GROUP	MODEL
Safety Recall Campaign	2016-2018MY K900(KH) 2014-2016MY Sportage (SL)
NUMBER	DATE
SC227A/B (Rev 1, 09/20/2022)	April 2022

HECU FUSE/MULTI-FUSE REPLACEMENT (SC227A/B)

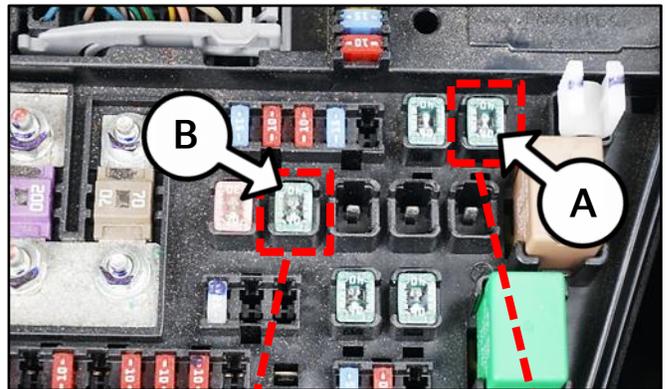
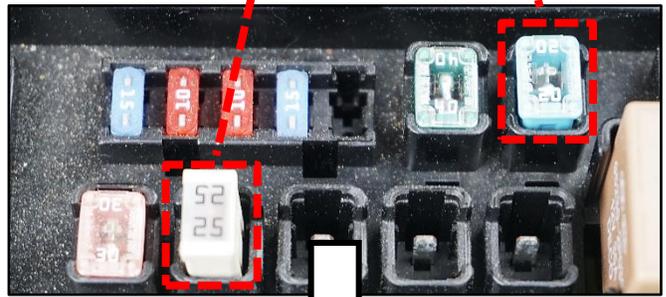
- 3a. Remove two (2) 40A fuses (A) and (B).

- 3b. Install the new amperage fuses as follows:

- A. ESC1 fuse → new 20A
- B. ESC2 fuse → new 25A

Ensure to replace ESC1 fuse (A) with the 20A fuse and ESC2 fuse (B) with the 25A fuse.

5. Adhere the new ESC1 20A and ESC2 25A labels to the bottom of the junction box fuse cover as shown.

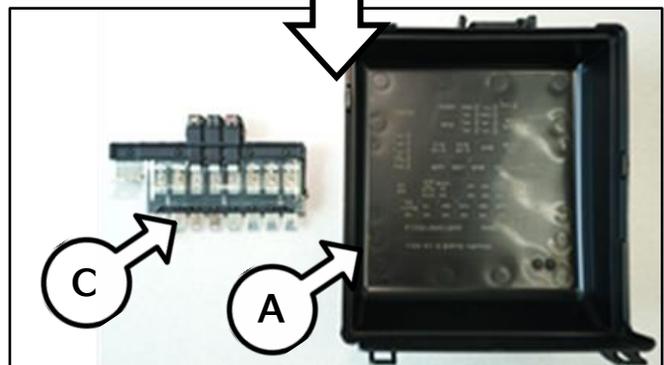
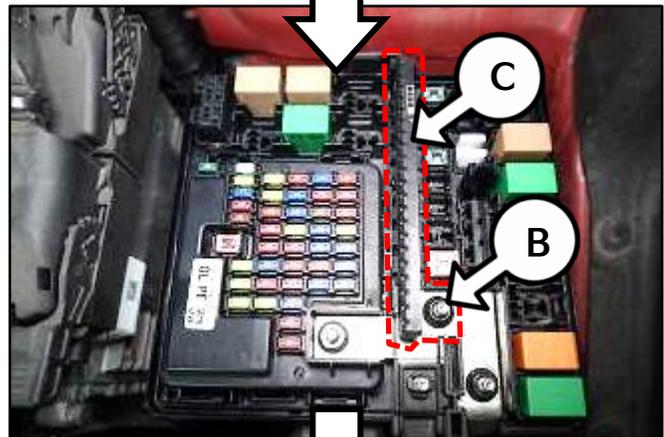
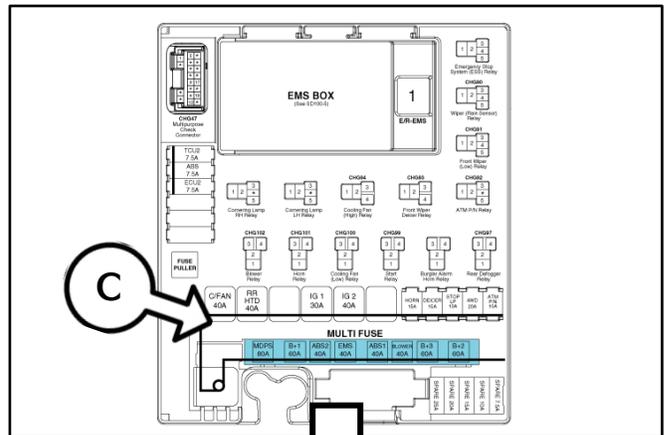
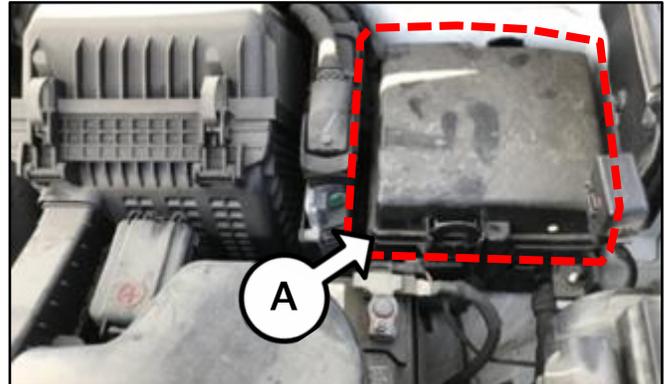
1. Open the hood.
2. Remove the junction box fuse cover (A).
3. Remove the multi-fuse retaining nut (B) and remove the multi-fuse (C).

- ABS 1 → new 30A
- ABS 2 → new 25A

Install the new multi-fuse (C) and torque retaining nut (B) to specification.

Tightening torque for Nut (B):
7.2 - 8.7 lb.ft (9.8 - 11.7 N.m)

Install the new junction box fuse cover (A).
